DEVELOPMENT REVIEW COMMITTEE (DRC) COMMENT REPORT

PROJECT NAME: Village of the Arts

CASE NUMBER: UDP-S23019

REQUEST: Site Plan Level II Review: 162 Multifamily Residential Units with 6,000 Square Feet of Retail/Commercial Use in the Northwest Regional Activity Center

ELEVATION

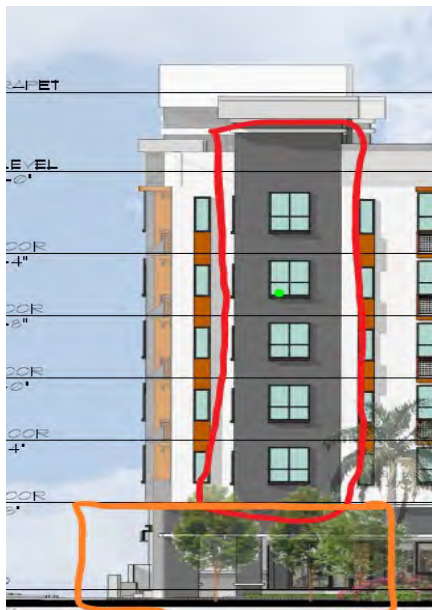
- g. B9d- Provide larger first floor, floor to ceiling windows, and/or integrate transom windows where necessary to enhance the public realm along NW 6th Street and wrap these elements around NW 5th Avenue and NW 6th Avenue. Although the interior floor height is 15 feet, 8 inches, the building feels truncated due to the height of the windows and arcade. Increase the height of the arcade to reflect the actual height of the first floor.

Northeast Frontage

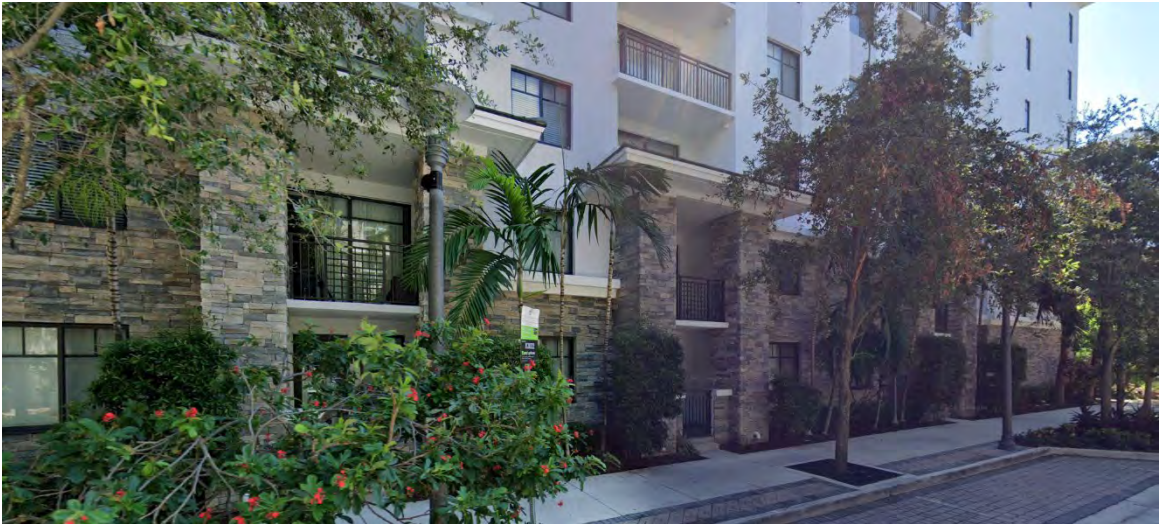
- h. B14-
 - i. Additional architectural emphasis needs to be placed on the northeast corner. An example of a more active and expressive design is the building's northwest corner, which contains high levels of fenestration and balconies. Add additional architectural features to the northeast corner.. Reference images, below.

- iii. Provide additional windows on northwest and southwest facing units as identified in the images below.

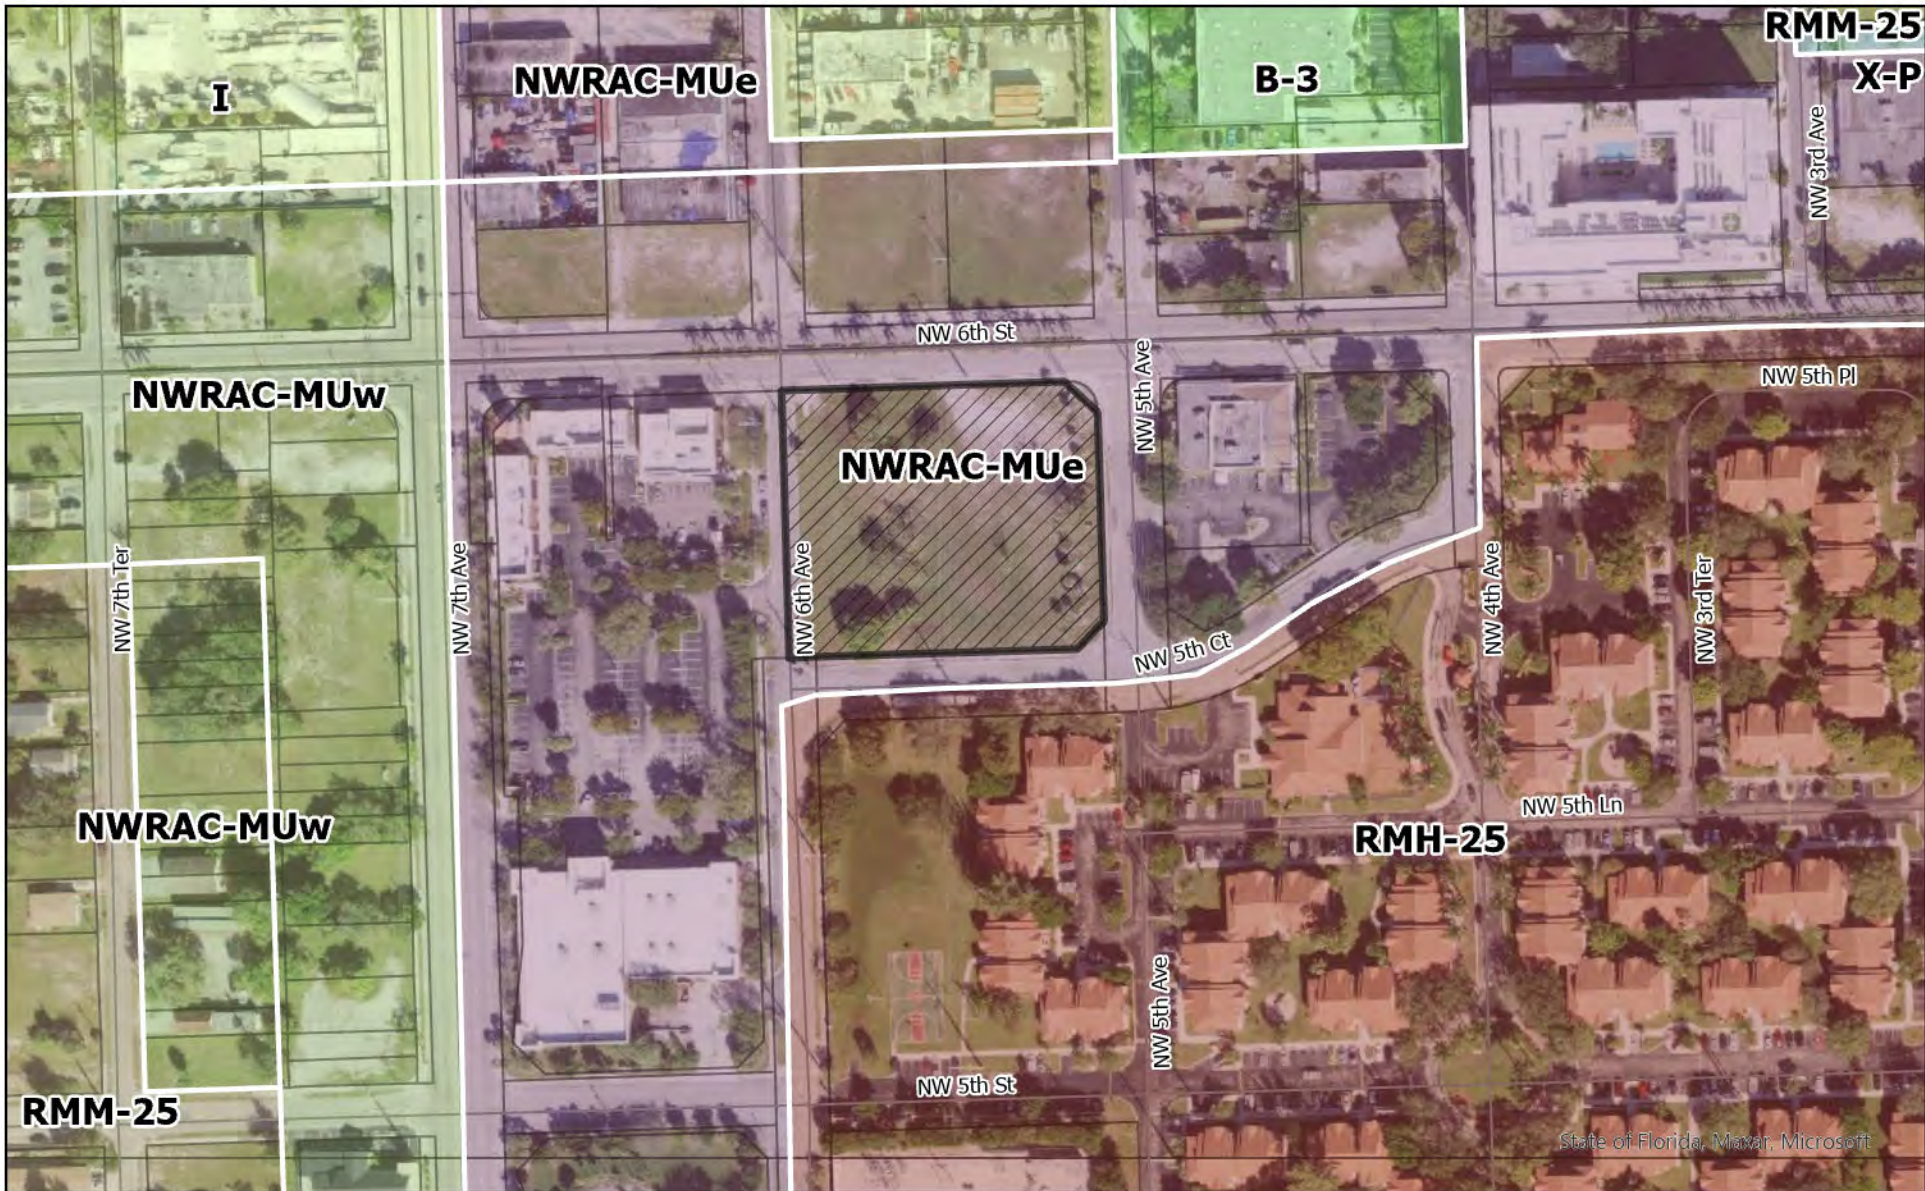
12. Provide the changes on the elevations:
 - a. Update rooftop plans and spot elevations to reflect the proposed parapet walls that are reflected on the elevation plans.
 - b. Provide dimensioned street sections for each elevation.
 The parapets will be highly visible from the ROW and will appear flat from vehicles and pedestrians approaching the building from the east and west. Provide additional depth to parapet walls denoted in blue below to match the design of the parapet walls denoted in green below.
